CITY COUNCIL AGENDA ITEM

AGENDA ITEM: **201303686** - 4890 Northland Drive, *Applicant: David L. Kuniansky*, to rezone from R-2 (Single Family Dwelling District) to R-2A (Single Family Dwelling District) to develop 2 single family lots, with a concurrent variance

To: John McDonough, City Manager
From: Angela Parker, Director of Community Development 
Date: February 4, 2014 for submission onto the February 18, 2014 City Council meeting
Agenda Item: **201303686 4890 Northland Drive** a request to rezone the subject property from R-2 (Single Family Dwelling District) to R-2A (Single Family Dwelling District) to allow the two (2) single family lots, with a concurrent variance.

Rezoning Petition No. 201303686

SITE PLAN

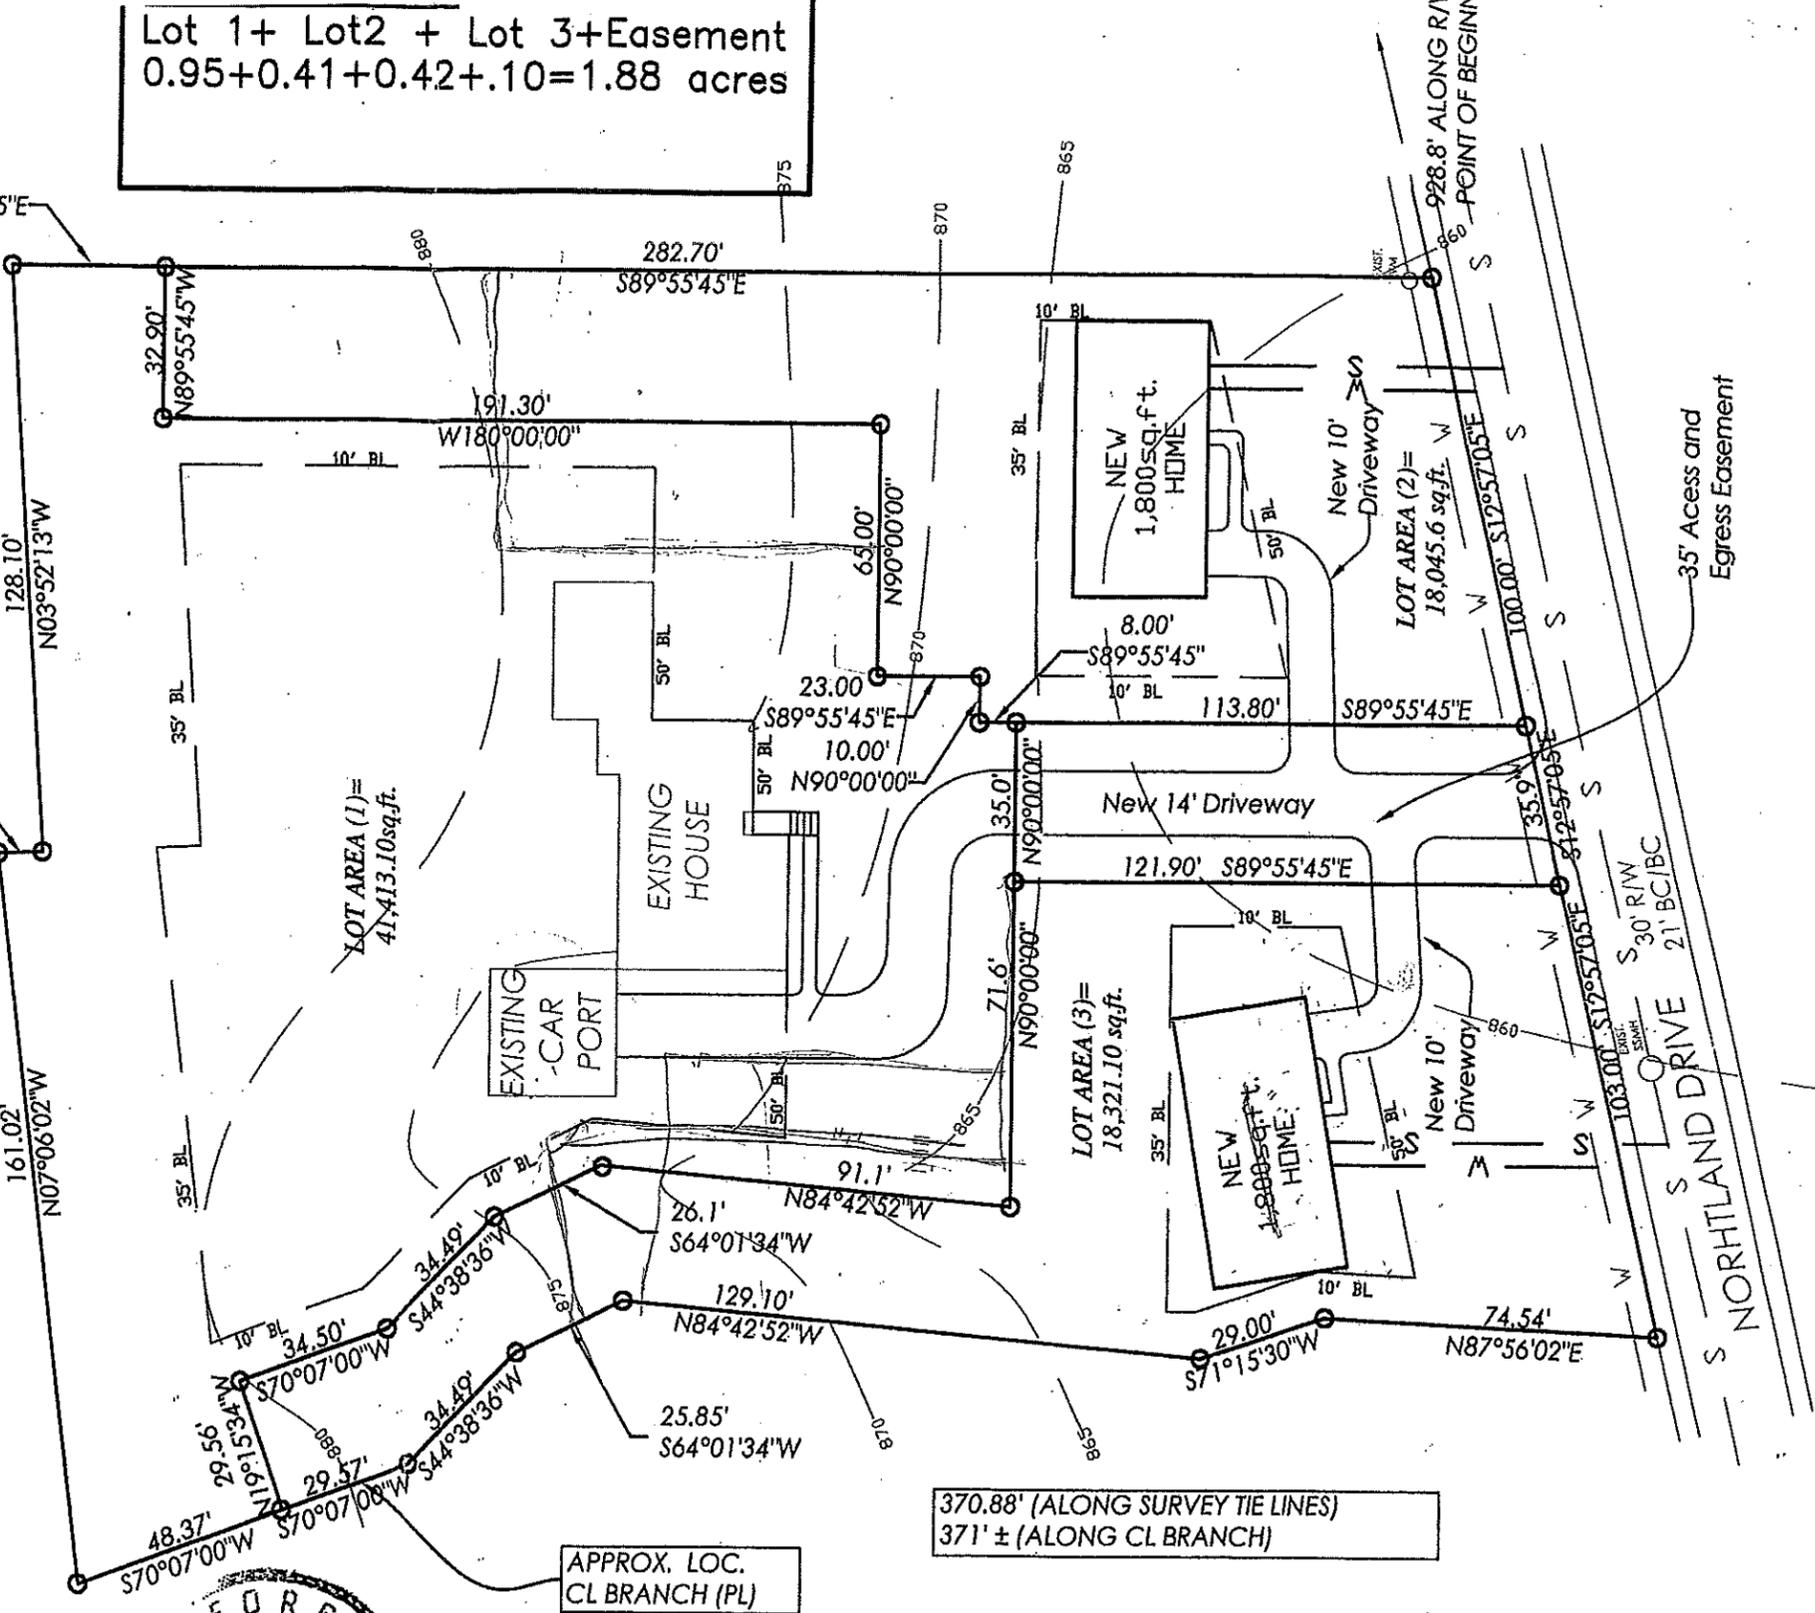
Prior to the Planning Commission Hearing on January 16th,2014, two neighbors, Terence Tracy and Charlie Kontz, wrote letters objecting to the rezoning based on their belief that the previous owner of this parcel applied for and was denied by Fulton County an "exact" or "similar" plan, depending on which gentlemen's letter you read. As I pointed out in my verbal remarks to the Planning Commission, these claims are not only inaccurate but misleading to all who have read them. I am sending you along with this printed email under separate cover a copy of the plat which accompanied the previous owner's application to Fulton County in 2003. Please note that his proposed rezoning called for two additional lots, of 18,000 square feet each ,to be carved out of the front yard of the property, making three total lots on this property while my proposed plan would result in two houses total.

While my original site plan called for two lots, one being "L" shaped and larger and the other being rectangular but significantly smaller (Mr Tracy stated that this appeared to be a "flag" lot), however, this original plan by definition of a flag lot by the City of Sandy Springs is not a flag lot.

I attended the 12/18/13 Community Developer Resolution Meeting on the subject property and stated my objection to the application based on similar objections raised to a prior application by the previous property owner before the City came into existence that it would have created a "flag" lot of which no others currently exist on Northland Drive (or in the immediated surrounding area to the best of my knowledge). You indicated at the meeting that night that this application does not result in the creation of a flag lot as defined by City of Sandy Springs zoning regulations. While the current application may not technically meet that definition, I believe that "visually" it certainly appears to be in a flag shape that will result in one house(which is conveniently not layed out in the application) almost by necessity lying partially behind a second that is sited closer to the street. I am unaware of any other such lot/house configurations certainly on Northland Drive or in the nearby surrounding area similar to what is being proposed. It is my belief that such a resulting configuration is totally out of character with the surrounding homes and would potentially set an ultimately negative precedent.

Ms. Abaray, The previous owner tried to rezone exactly as the new owner is trying to do. I was President of HPCA at the time & we were successful in getting this Zoning turned down for the watershed issue & existing zoning on the property. Nothing seems to have changed & Sandy Springs should turn this zoning down also. Please keep me apprised.

That being said I understand why my future neighbors object to this non-conforming appearance and I have adjusted the revised plan submitted last week to even out the area of the two lots so that one is 1.058 acres and the other is .9087 acres and the property line between them is a straight line from the street to the rear property line. This shape now conforms with other surrounding lots; is consistent with the City's Future Land Use Map and the density is consistent with the Comprehensive Plan. In addition I have withdrawn my request for a variance by reducing the stream buffer.
